Hancock Village Traffic & Drainage Review

Is the Drainage Design based on flawed data gathering?

Potential Vernal Pool on the site behind Beverly Road?

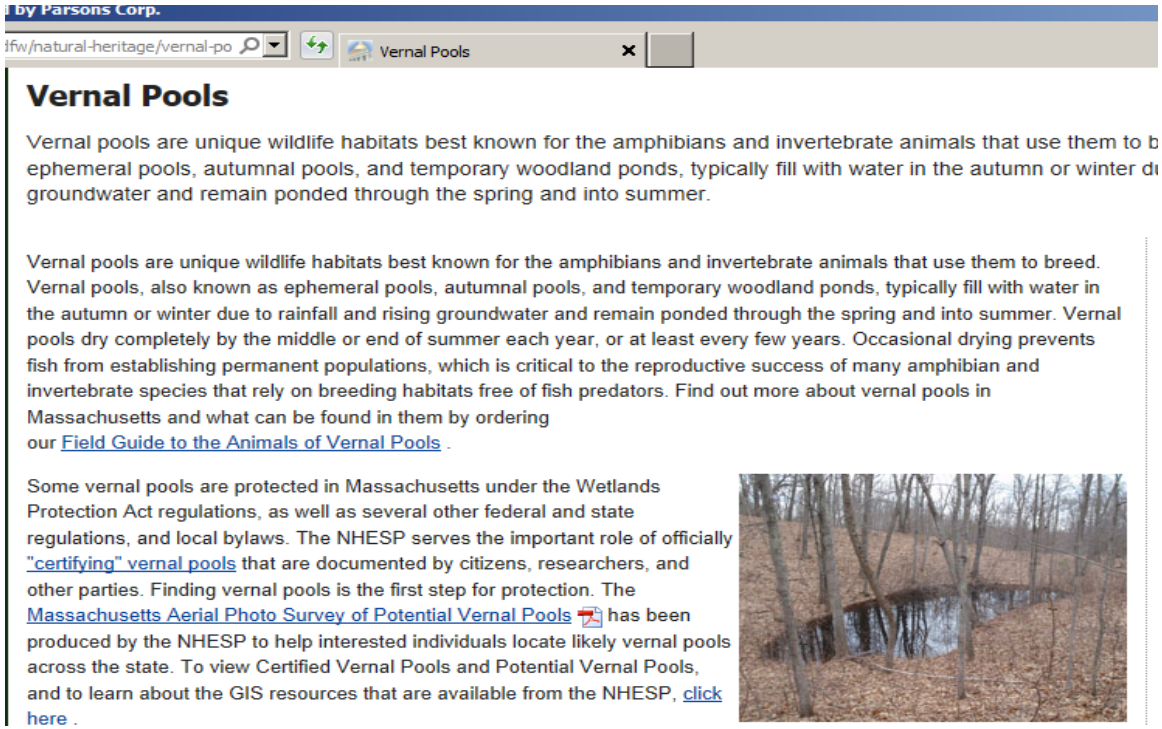
The photograph of the pooling water on Beverly Road looks substantially similar to the above picture of a vernal pool on the Energy and Environmental Affairs website.

- Has CHR asked the EEA to see if the pools on their site are candidates for protection? Should the Town of Brookline ask?

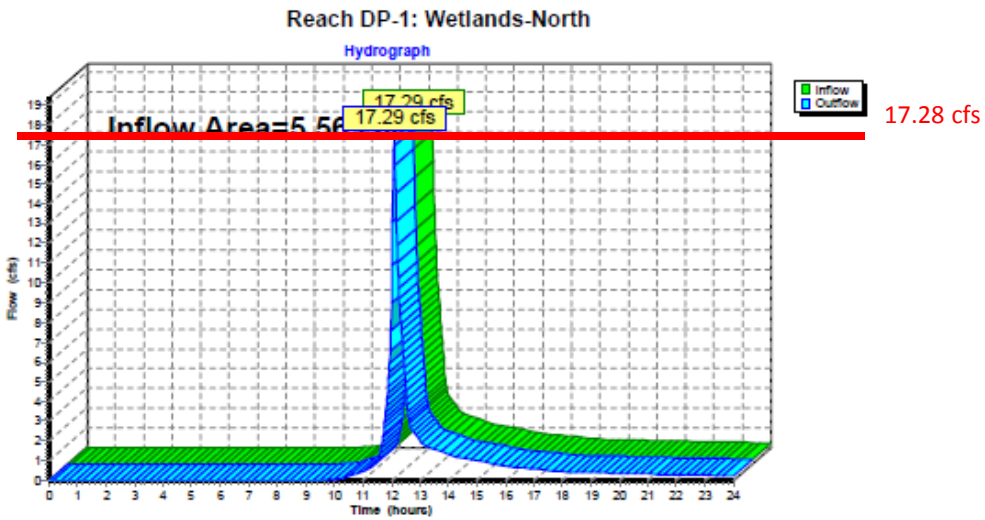
- CHR's design is based on the peak flow of a 24 hour event, which usually occurs over a brief (a few minute) period.
- Technically, as long as the Post development peak is less than the Pre development peak, the design is acceptable.
- If you were to design a system that delivered 17.28 cfs constantly over 24 hours you could claim to have a compliant system.
- This compliant system would result in additional runoff from the site of more than 11,167,500 gallons of water.

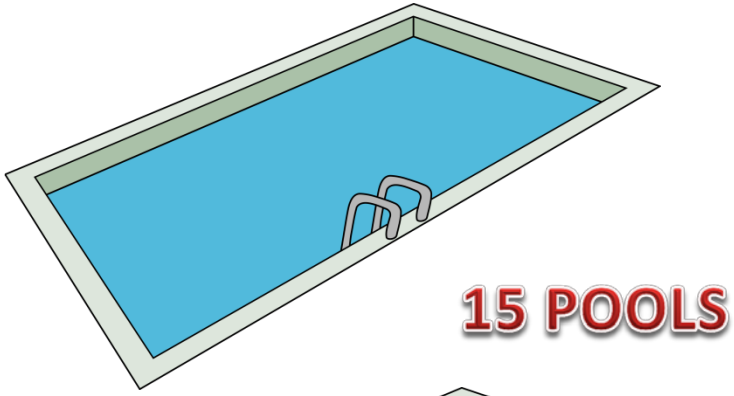
For a 10-year storm the existing run-off from the site is 0.717 Acre-Feet

For a 10-year storm the proposed run-off from the site is 1.45 Acre-Feet

The net effect is 0.733 Acre-Feet, which is twice the original amount

This translates into an additional 241,781 gallons

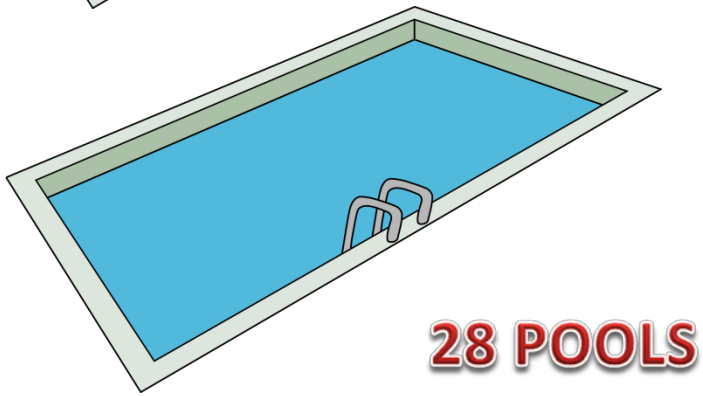
For a 100-year storm the exsiting run-off from the site is 3.292 Acre-Feet

For a 100-year storm the proposed run-off from the site is 4.672 Acre-Feet

The net effect is 1.38 Acre-Feet

This translates into an additional 449,675 gallons

5 P-4C STORMTANK CHAMBERS
SCALE: NTS

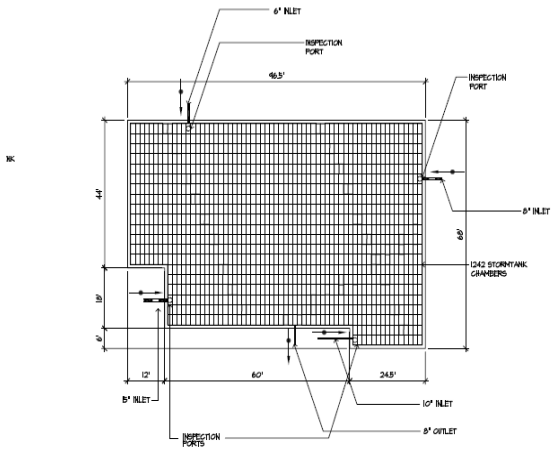
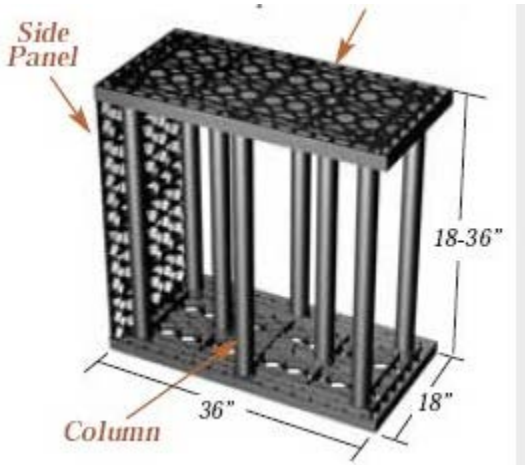
- This is not a proven technology. StormTank systems come with a 12 month limited warranty.
- This system is equivalent to building an underground storage tank out of thousands of milk crates.
- The Geotech has not provided the Bearing Capacity of the soils, soil composition, limiting zones, etc. that the manufacturer requires.
- Lateral loads from adjacent structures could compromise the system. These systems are located near adjacent structures that need to be analyzed.
- Drainage ports shown do not comply with manufacturers'recommendations showing the designer has little experience with these systems.

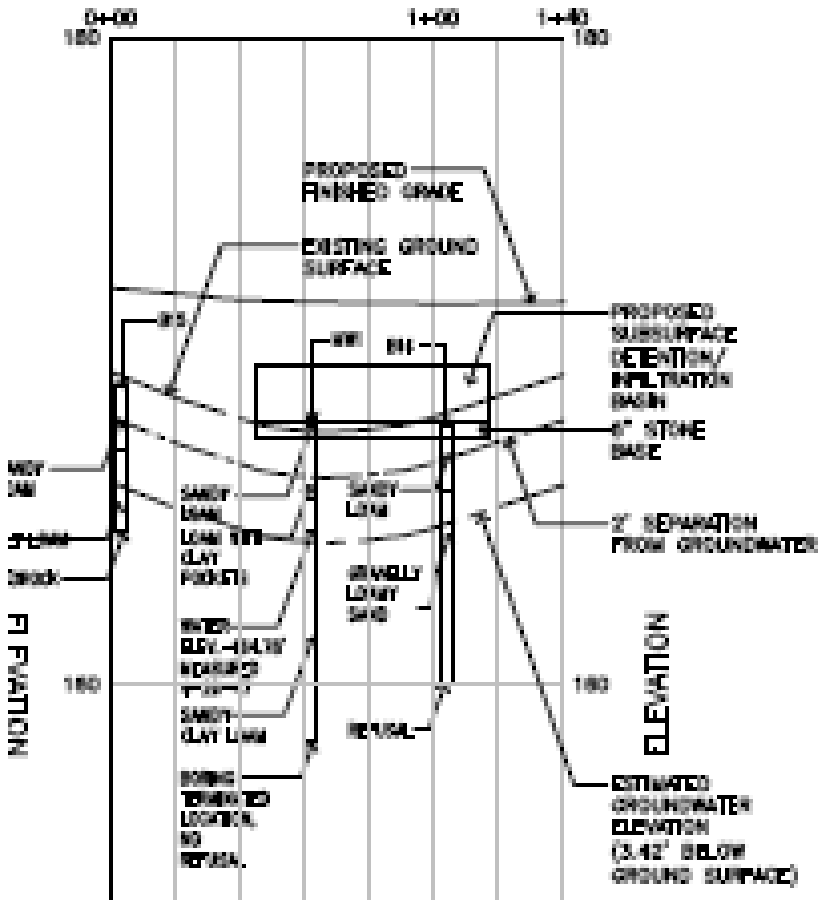
The Architectural Reviewer recommended keeping the natural grades of the existing site. Why is the site built up in places?

- The ground water elevation at Basin 1A is extremely high.
- They must build up over the existing grade to fit in their stormwater holding tank.
- If the Seasonal Ground Water elevations are higher than assumed, the system could fail!

Steep Rock Excavation

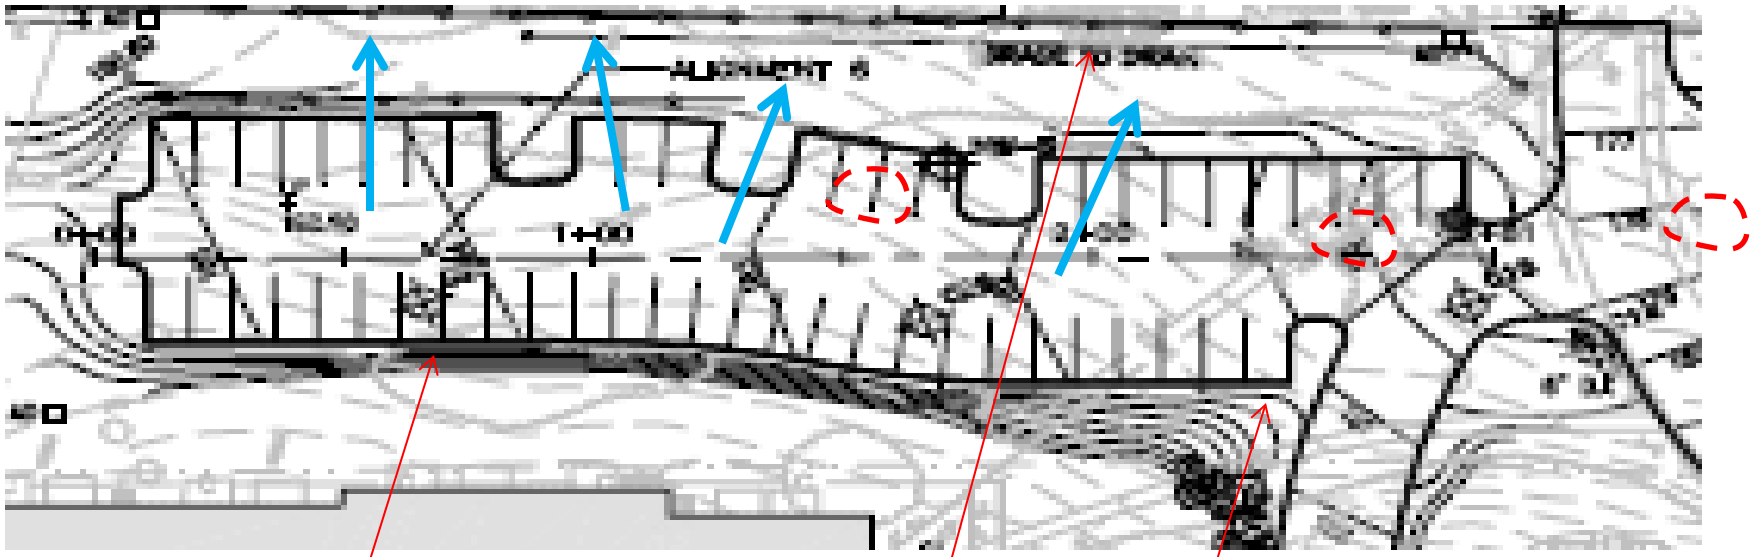
How are the Area Drains installed without removing vegetation that is supposed to remain?

The plans call to “Grade to Drain”. There is no proposed grading shown and these trees are supposed to be saved.

Proposed Porous Pavement Detail.

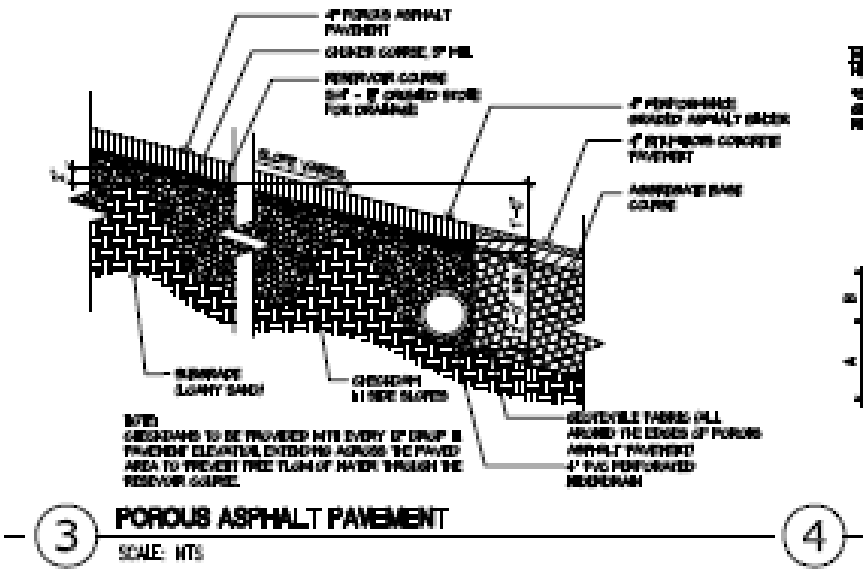
- The detail provided says the subgrade will be “loamy sand.” The cross section shows the subgrade material will be solid rock.
- The detail calls for checkdams. Will these be carved into the rock? These dams will direct water towards Russet Road.
- The minimum section is approximately 3’ deep. In some cases, the proposed elevation is 5’ below existing grade. There could be rock excavation of over 8’!
- The proposed parking lot will create a bath tub out of rock with the primary exit towards the residences on Russet and Asheville Road.
- The 4” underdrain is only located at the west end of the parking lot. The majority of the water will be heading towards the Russet Road residences instead of flowing to the drain.

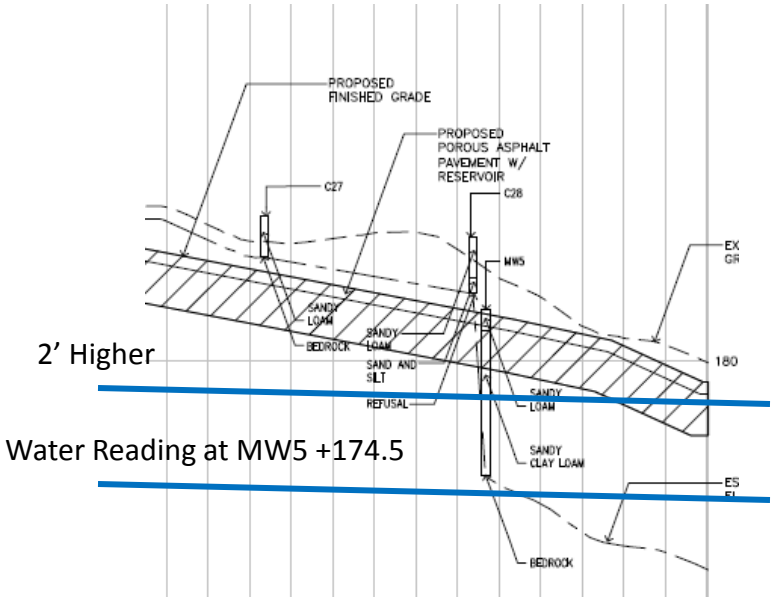
There is not proper separation between the water table and storage

- Well MW 5 had a water reading of 174.5
- Two feet above that is 176.5
- The low point of the pervious pavement parking lot is 179.0
- The pervious pavement is 3' deep.
- 179'-3' = 176' which only allow 1.5' separation.

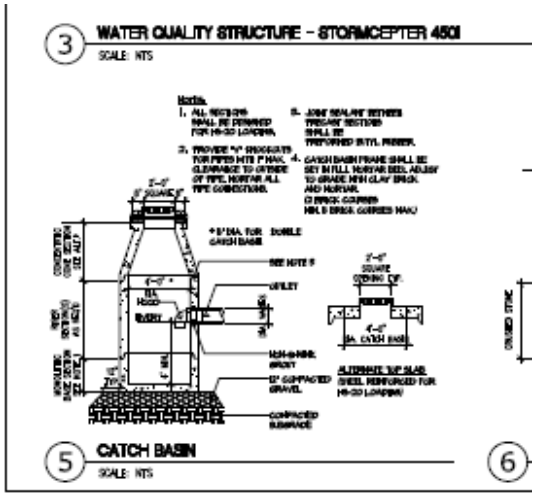
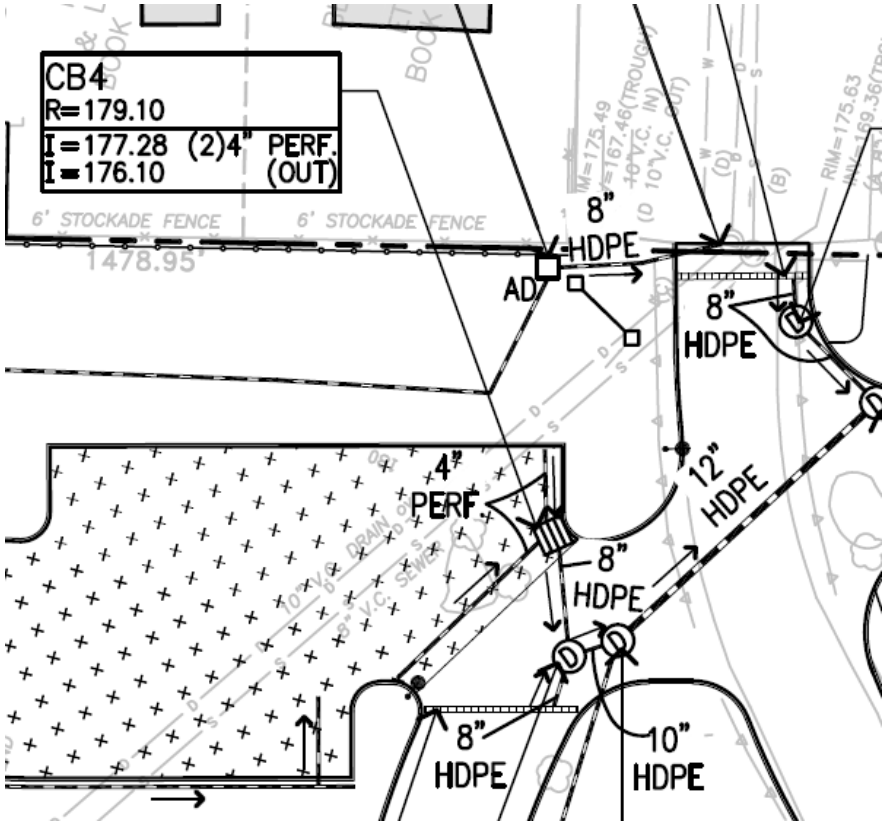
- Catch Basin CB4's rim is proposed to be at El. 179.10, about 1' below existing rock.
- The bottom will be at El. 170.6 about 10 feet below existing rock.
- All the proposed drain lines shown left will have to have deep cuts blasted into the rock in order to install them.
